Access Compliance Report

Public Rights-of-Way

Intersection ID: 28334	Main Street: CASTLEBAY_DR	Cross Street: NETHERFIELD_CT	Location: S
ADA ID: 2CDA377981CB	Ramp Type: BlendTrans2	Initial Pass/Fail: Fail	Overall Compliance: No
		Severity Score: 12.5

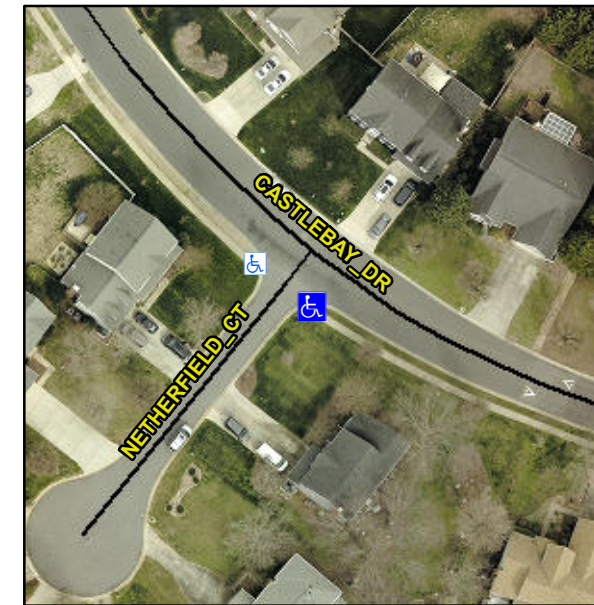
Not Found, R304.5.3

Compliance	Description	Data	Compliance	Description	Data
N/A	Ramp Length (in)	62.0	Yes	BlendTrans Slope (%)	4.5
Yes	Ramp Width (in)	48.0	No	BlendTrans XSlope (%)	5.6
N/A	Flare Type LT	N/A	N/A	Flare Type RT	N/A
N/A	Flare Slope LT (%)	N/A	N/A	Flare Slope RT (%)	N/A
N/A	Flare Traversable LT?	N/A	N/A	Flare Traversable RT?	N/A
N/A	Landing Length (in)	N/A	N/A	DWS Provided?	N/A
N/A	Landing Width (in)	N/A	N/A	DWS Contrast?	N/A
N/A	Landing Slope (%)	N/A	N/A	DWS Length (in)	N/A
N/A	Landing X Slope (%)	N/A	N/A	DWS Full Width?	N/A
N/A	Landing Curb? (Y/N)	N/A	N/A	DWS Offset (in)	N/A
N/A	Shared Landing?	N/A			
N/A	Gutter Ponding?	N/A	N/A	Gutter Slope (%)	N/A
N/A	Gutter Lip Ht (in)	N/A	N/A	Gutter X Slope (%)	N/A
N/A	Painted X Walk1?	No	N/A	Painted X Walk2?	No
	X Walk 1 Direction	To NE		X Walk 2 Direction	To NW
	X Walk 1 Width (in)	N/A		X Walk 2 Width (in)	N/A
	X Walk 1 Slope (%)	1.6		X Walk 2 Slope (%)	2.3
	X Walk 1 X Slope (%)	2.6		X Walk 2 X Slope (%)	2.8

N/A	Ramp inside XWalk1?	N/A	N/A	Ramp inside XWalk2?	N/A
	Road Slope (%)	2.7		Clear Space?	N/A
	Road X Slope (%)	0.1	N/A	Clear Space to XWalk (in)	N/A
N/A	Any Obstructions?	N/A	N/A	Storm Grate/Utility Hazard?	N/A
	Obstruction Type			Storm Grate/Utility Type	
		N/A			N/A
			Yes	Surface Condition? (G/P)	Good
			No	Curb Slope (%)	21.8

Remove & Replace Curb Ramp With Two New Directional Ramps or Equivalent.
